### C-17-14

Rezone R-1 and A-1 to RS and B-2

# C-17-14(c), CHAMBERLAYNE ROAD ASSOCIATES, L.L.C.

Residential and Commercial Rezoning Report  
Chickahominy Magisterial District  
PC Meeting Date: February 19, 2015

**STREET TREE LANDSCAPE LEGEND**

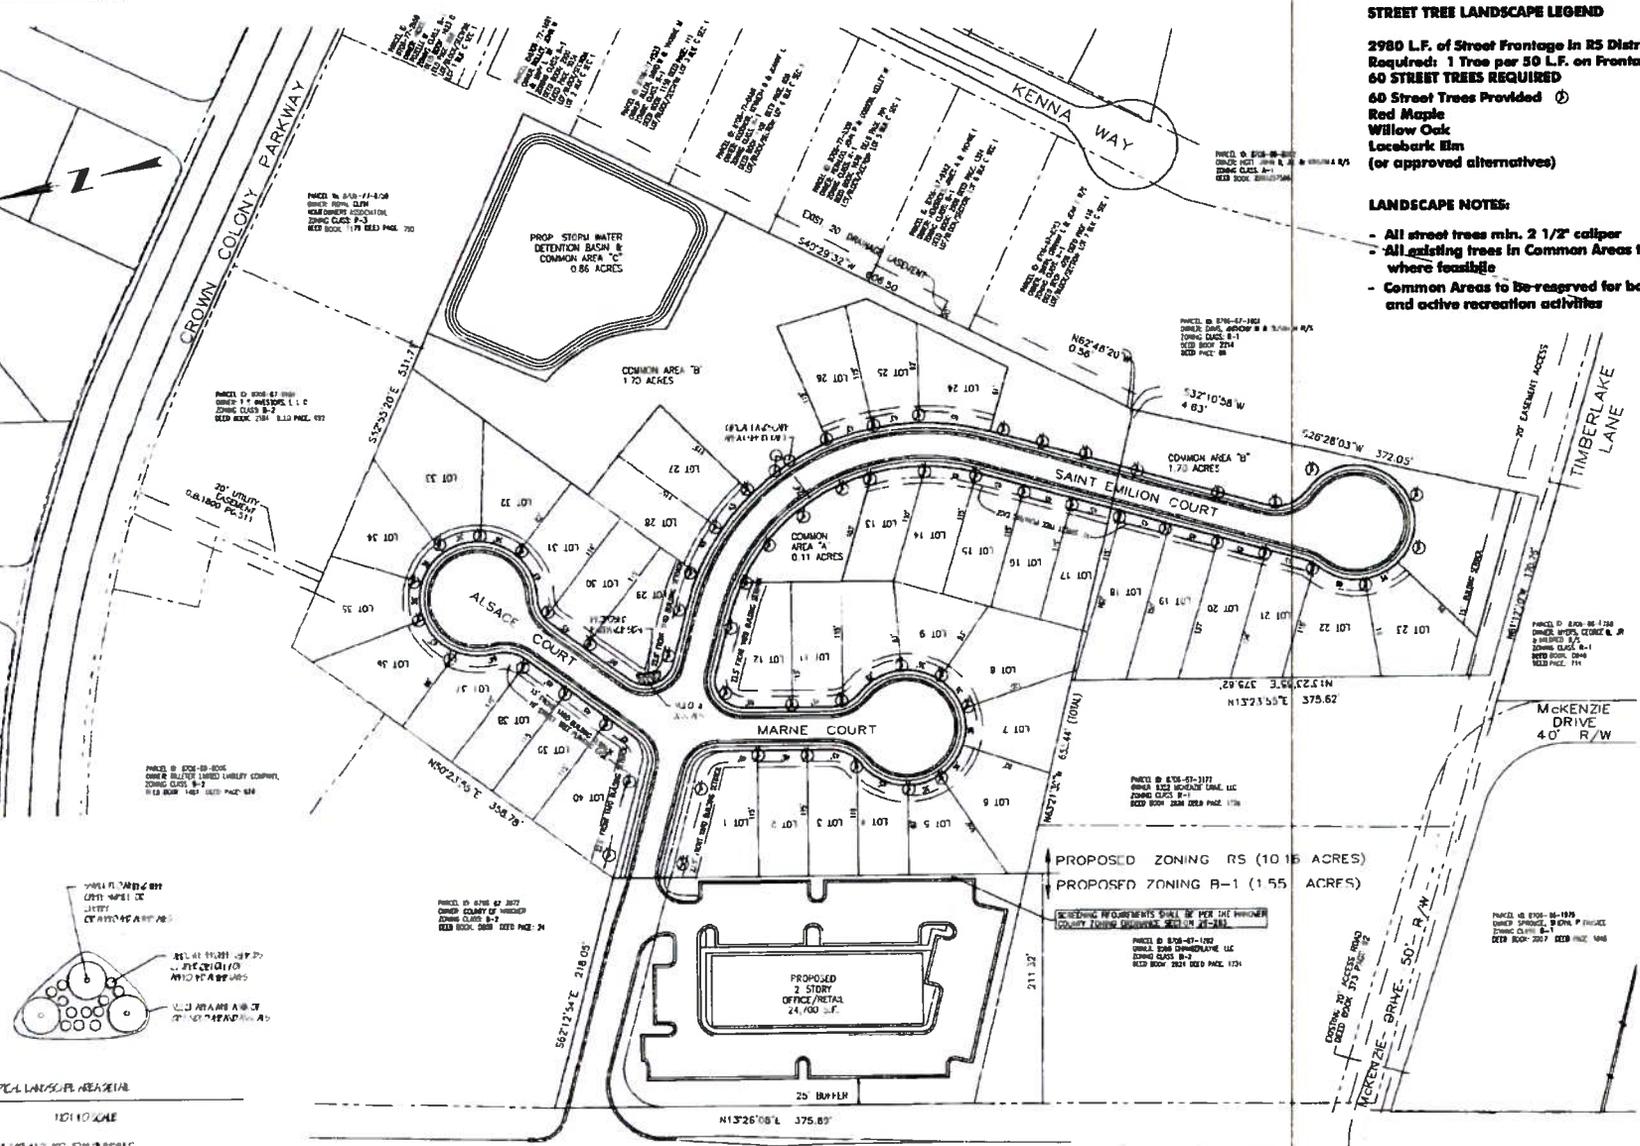
With the exception of the proposed stormwater detention basin located to the rear of the common area as well as some supplemental landscaping, it is unclear whether the common areas will be altered from their natural state. Staff would recommend that the conceptual plan provide more detail on these areas, especially along the common border with Crown Colony.

the sidewalks that connect to the future B-2 use as well as use the pedestrian path across the B-2 area to access the adjacent existing businesses, which currently consist of a seafood market and produce stand. The staff recommends that plan be revised to show a pedestrian path or sidewalk constructed within the thoroughfare buffer along U.S. Route 301 to connect with the existing businesses.

The conceptual plan demonstrates how this strategy has been achieved through the placement of convenient and contiguous open space throughout the development. However, the plan is unclear as to how the common area will be improved or altered from its current condition. Staff would recommend that the plan be revised to show how common areas will be graded, landscaped, and seeded to be suitable for passive recreation.

With exception of the site improvements needed for the stormwater basin and the proposed supplemental landscaping, the conceptual plan is not clear as to how the trees in the common areas would be preserved. As previously mentioned, staff would recommend amending the plan to show how common areas will be altered. To further address community concerns, staff would also recommend a note on the plan requiring a 15' undisturbed natural buffer be maintained within the common area along Lots 24 and 25.

1. Revise the conceptual plan to show a sidewalk or pedestrian path within the thoroughfare buffer to connect to the adjacent commercial property.
2. Clarify on the plan whether the open space shall be maintained in its natural state or delineate areas to be graded and seeded to be more suitable for passive recreation activities.
3. Provide a note on the plan to indicate that a 15' undisturbed natural buffer shall be maintained in the common area behind Lots 24 and 25.
4. Provide an additional proffer regarding the historic house, as recommended by the Historical Commission:
